SAFETY RECALL BULLETIN

SUBJECT: Steering Gear Mounting Fastener Torque

Certain VNL, VNM, and VT model vehicles manufactured from July 2, 2007 through September 21, 2007.

W6001615

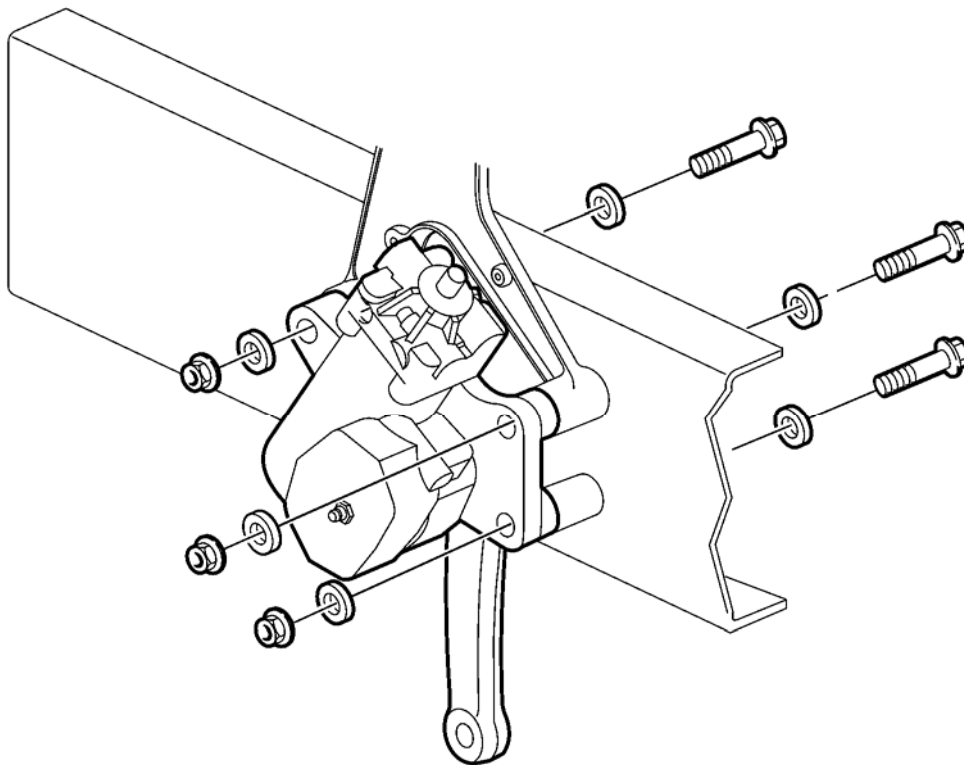
The bolts that attach the steering gear to the frame may not have been tightened to the correct torque.

The recall repair will consist of tightening the bolts.

Using an accurately calibrated torque wrench on the mounting nuts (outer) and a wrench on the bolts (inner), tighten the fasteners to 398 ± 66 ft-lb (540 ± 90 Nm). **Note:** Some vehicle may have four bolts securing the steering gear.

3. Mark each nut with a yellow paint stick to signify that the fasteners have been torqued to specification.
